Revised Draft Supplemental Generic Environmental Impact Statement On the Oil, Gas & Solution Mining Regulatory Program

This report responds to the Natural Resources Defense Council's (NRDC), and its partner organizations Earthjustice, Inc., Riverkeeper, Inc., Catskill Mountainkeeper and Delaware Riverkeeper Network, request for a review of the New York State (NYS) 2011 Revised Draft Supplemental Generic Environmental Impact Statement (RDSGEIS) on the Oil, Gas & Solution Mining Regulatory Program Well Permit Issuance for Horizontal Drilling and High-Volume Hydraulic Fracturing to Develop the Marcellus Shale and Other Low-Permeability Gas Reservoirs and proposed revisions to the New York Code of Rules and Regulations (NYCRR).

NRDC, and its partners, requested a technical review of the RDSGEIS and the proposed revisions to the NYCRR to determine if best technology and practices were included. NRDC has also commissioned additional experts; therefore, this list of recommendations is not exhaustive and is complementary to the work assigned to other experts. A complete list of expert recommendations can be found in the summary cover letter submitted by The Louis Berger Group, Inc., on b

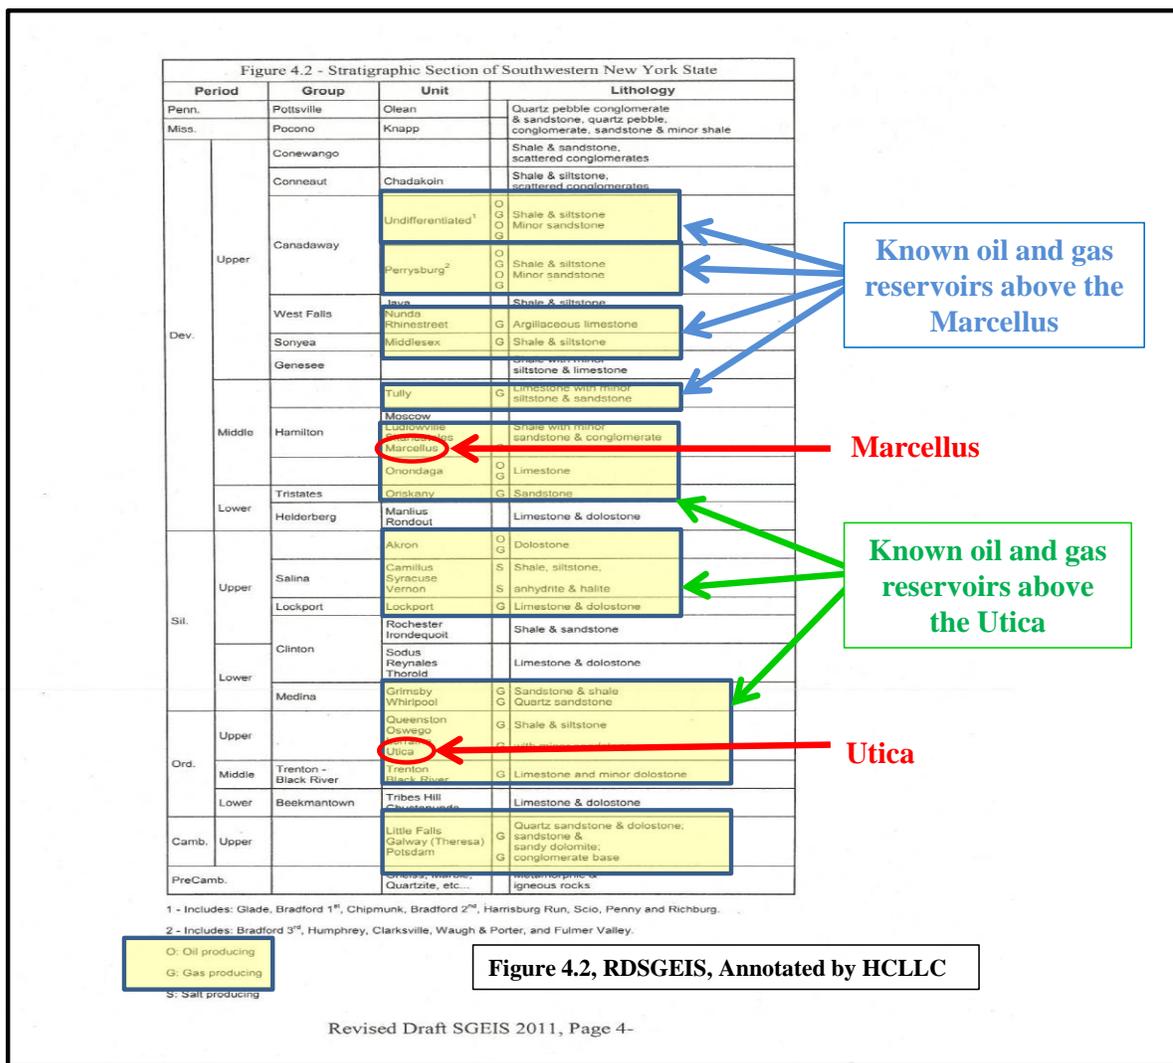
Figure 4.2 of the RDSGEIS⁶ includes a stratigraphic section showing existing known oil and gas intervals above the Marcellus and Utica Shales, including numerous shale and other low-permeability formations that are known to exist, that were not examined in the SGEIS.

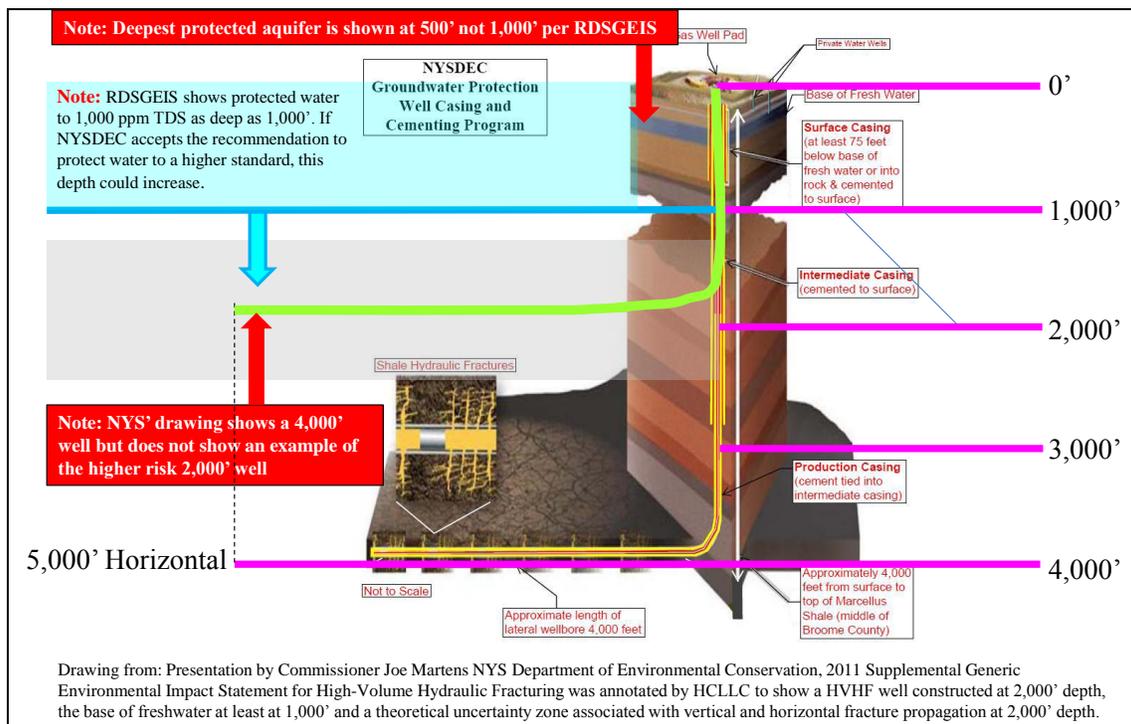
The drawing does not represent the highest risk wells proposed in the 2011 RDSGEIS. The highest risk wells allowed under the 2011 RDSGEIS would be drilled into a thin section of the Marcellus Shale at a 2,000' depth, with protected water located above at 1,000'. Below is an annotated version of this wellbore schematic, prepared by HCLLC, showing the higher risk wells proposed under the RDSGEIS.

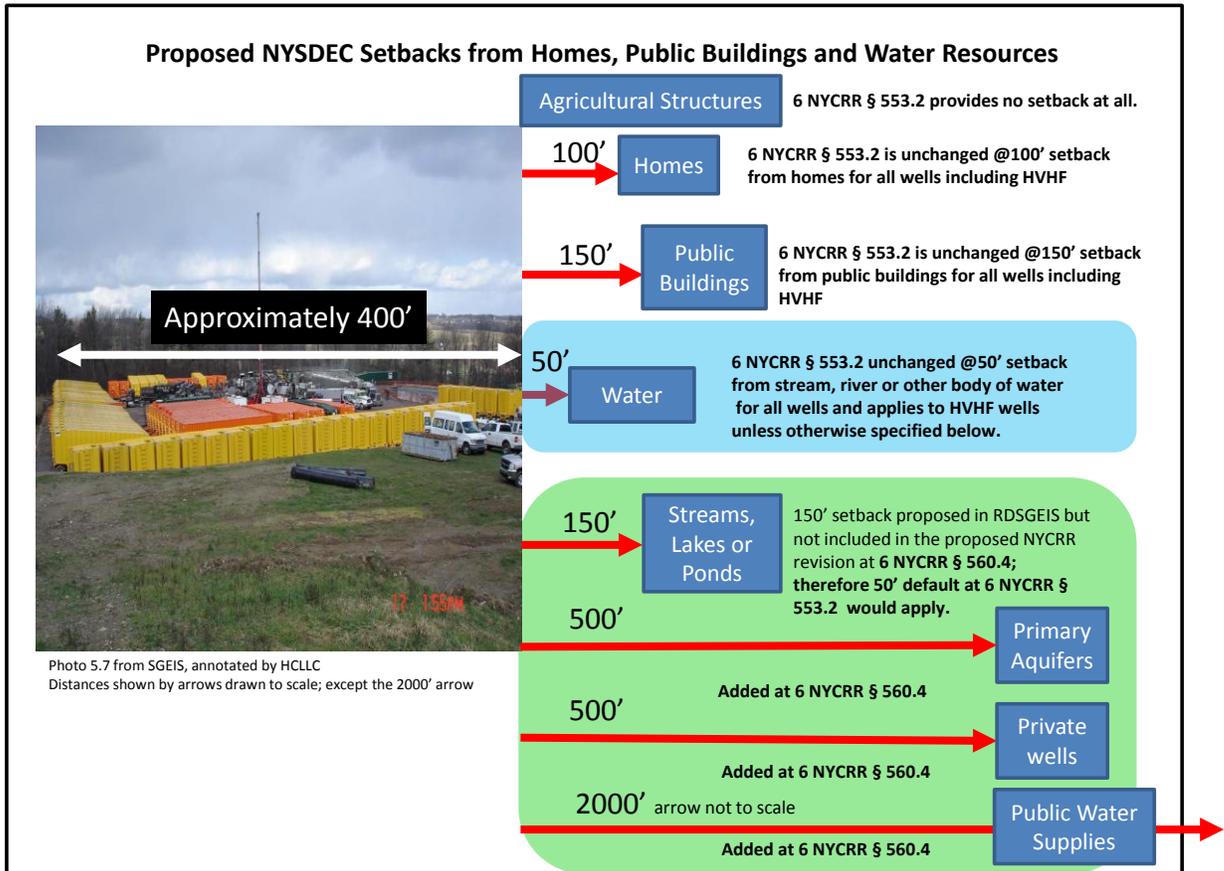
As shown in the figure below, the setbacks currently proposed in the RDSGEIS and in the NYCRR are inadequate. Shale drilling and HVHF operations within 100'-150' of homes and public buildings pose a direct safety risk, not to mention the health and quality of life impacts presented. NYSDEC is proposing

Recommendation No. 68: Improved setbacks should be included in the SGEIS as a mitigation measure and codified in the NYCRR. Specifically, the SGEIS and NYCRR should be revised at 6 NYCRR § 553.2 to include the following minimum setbacks: homes, public buildings, and schools (1,320'; ¼ mile); private and public wells, primary aquifers, and other sensitive water resources (4,000'); and other water resources (660'; 1/8 mile). Additionally, NYSDEC should clarify the authority of local zoning authorities to establish minimum setbacks that are more protective than NYS' minimum standards in order for localities to address unique and site-specific local concerns and community characteristics.

Figure 1: Figure 2 from Fisher (2010) showing the well centerline and a depth to the top of the fracture zone.

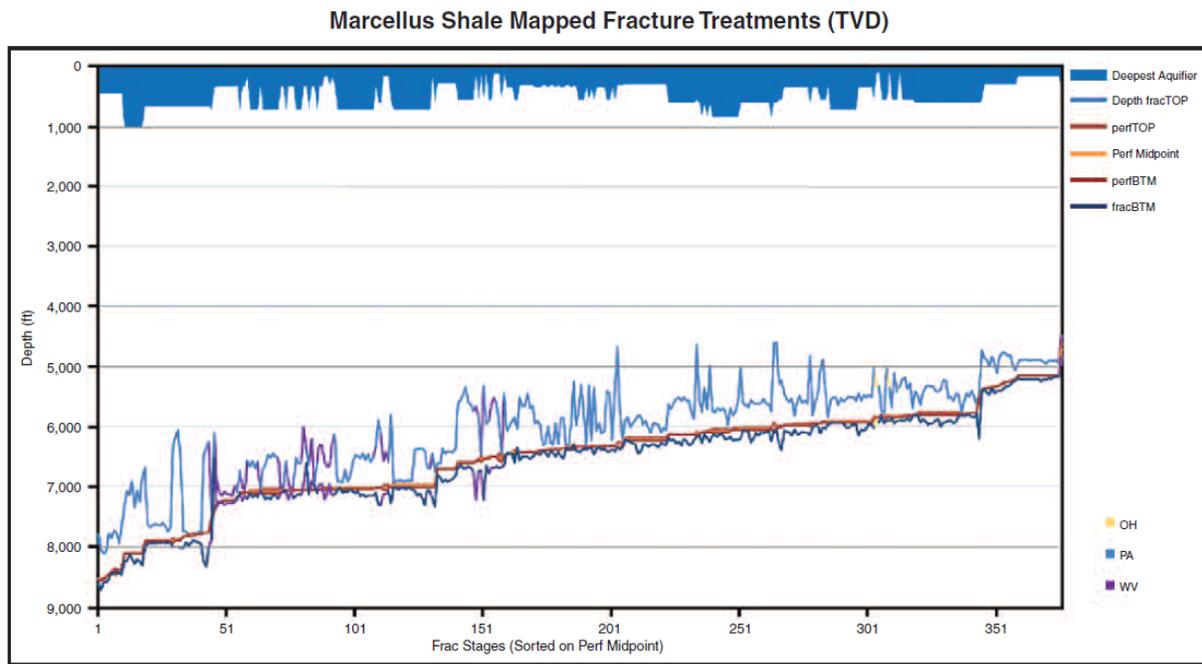
It is common practice to compare pressure and flow rate monitoring results from fracking operations to expected values from pre-fracking modeling as a method for evaluating the results of a fracking procedure (RDSGEIS, p. 5-88). Considering that many things affect the pumping flow rate, including pores between the well and the leading extent of the fluid moving away from the well, hydraulically it is difficult to imagine that a significant pressure drop would accompany the leading edge of the fluid reaching surrounding formations. Fracturing into surrounding formations would not bring additional water into the shale, as suggested (Id.), because of the pressures as described elsewhere (Myers in review). The increased porosity in the shale would release substantial brine bound in the shale.
